Addendum #3

Project: Village Court Apartments Phase IV
Mountain Village, CO
Date – August 29, 2019

ADDENDUM THREE

PROJECT NAME: Village Court Apartments Phase IV
415 Mountain Village Blvd
Mountain Village, Colorado

SHEET NO.
C-104

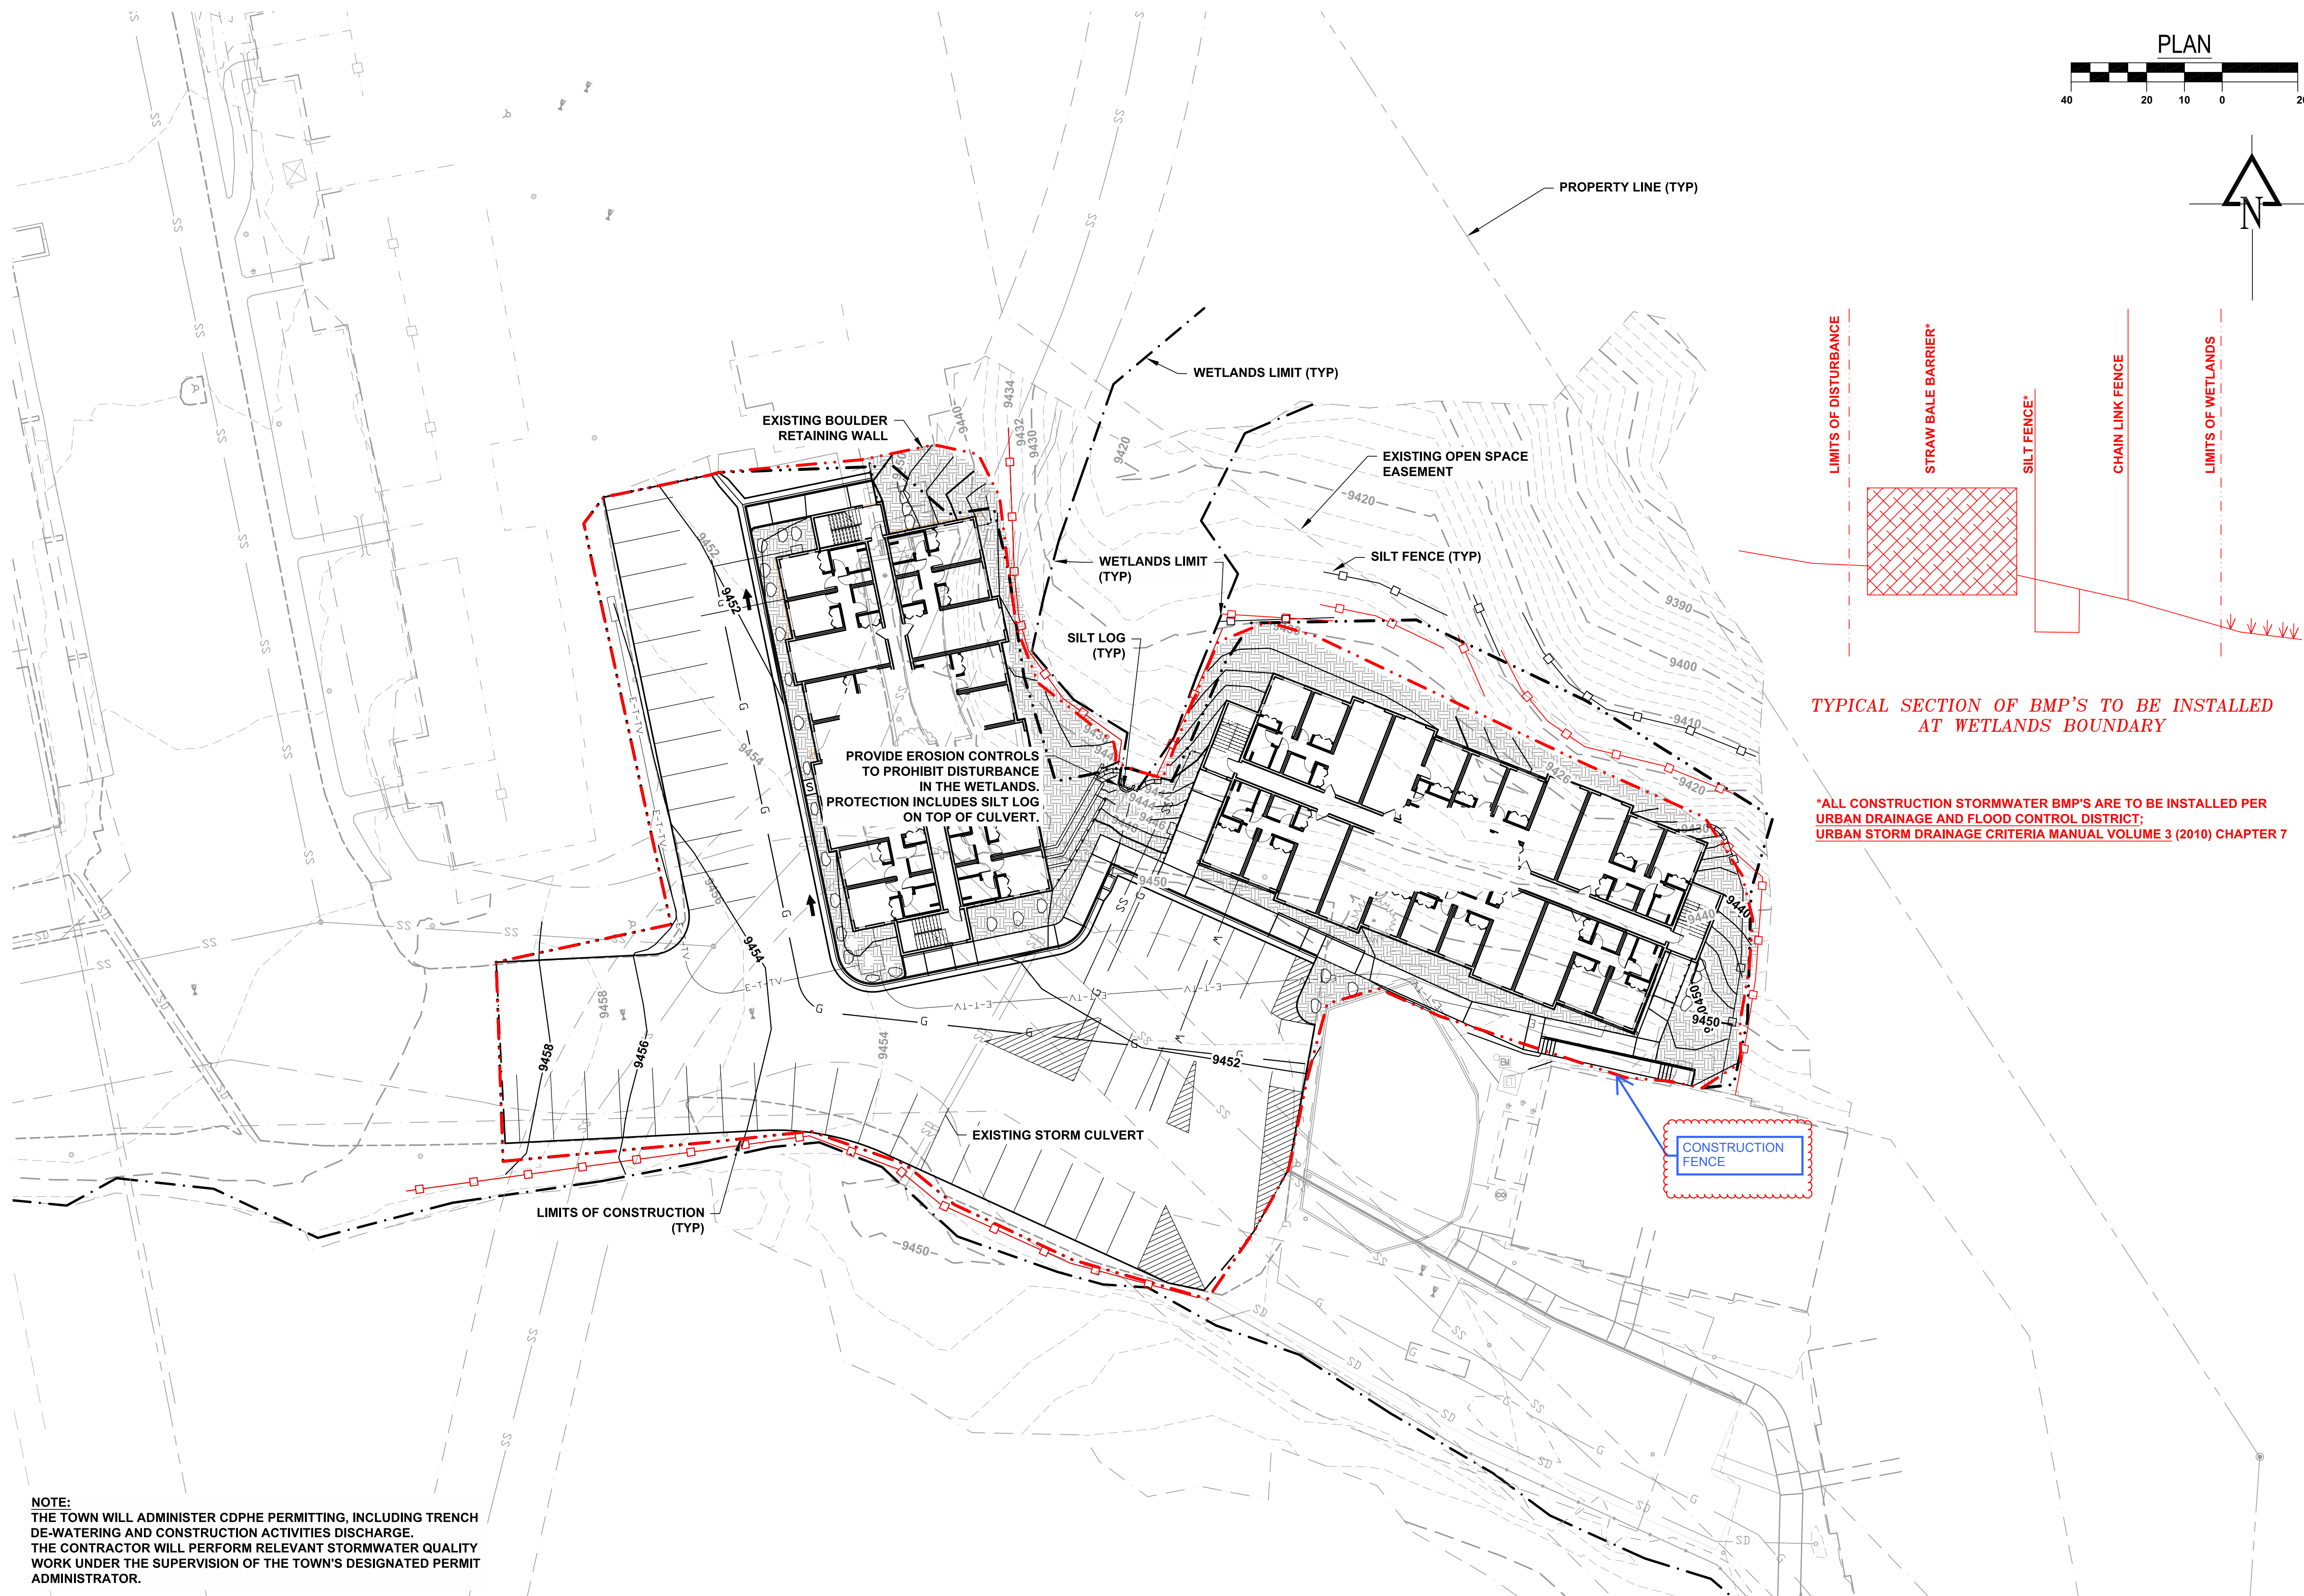
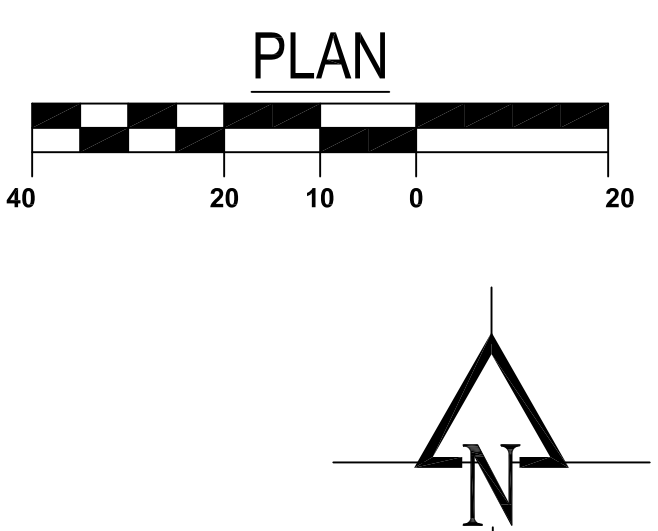
On the revised erosion control plan where is the construction fence located?

Response: A note has been added to the erosion control plan indicating which symbol represents the construction fence.
